CLEARANCES ON JOINTLY USED POLES

1.001 This Addendum supplements Section 620-216-013.

1.002 This Addendum is being reissued to include the bonding and grounding of power company gang operated switch rods.

Fig. 9.1—Inverted Power Construction

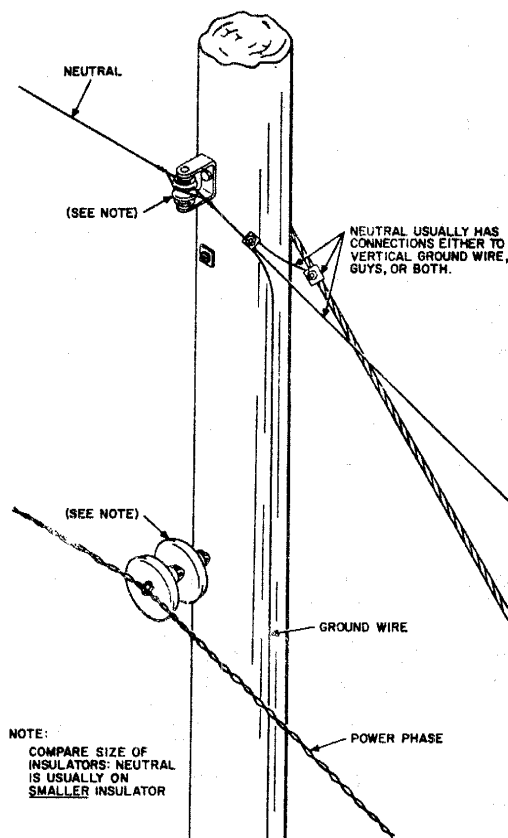
(a) 4.03 - Added note
(b) 4.03 - (c) through (h) - added
(c) 4.03 - Fig. 9.1 and 9.2 - added

Caution: Power companies occasionally attach the neutral ABOVE the phase wire as shown in Fig. 9.1. Therefore, it is important to identify the neutral wire before determining separation requirements. The neutral can usually be identified by observing the presence of the following:

If, after considering these factors, sufficient identification of the neutral wire has not been made, consult your supervisor or the electric utility company. However, if the neutral is attached above the phase wire, provide the clearance specified under paragraph 4.03 (a).

Fig. 9.2—Identification of Neutral at Transformer Location

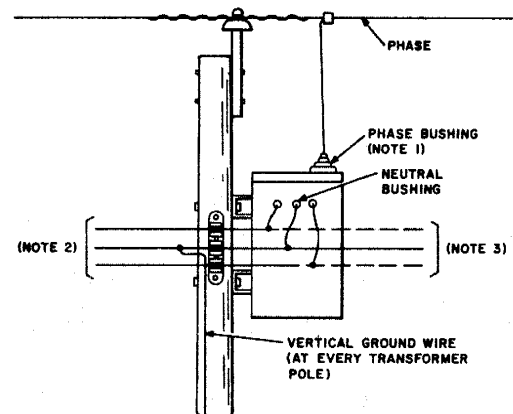
(g) On transformer poles, the bushing for the neutral is usually smaller than the bushing for the phase connection. The neutral bushing is often located near the secondary bushings (Fig. 9.2).
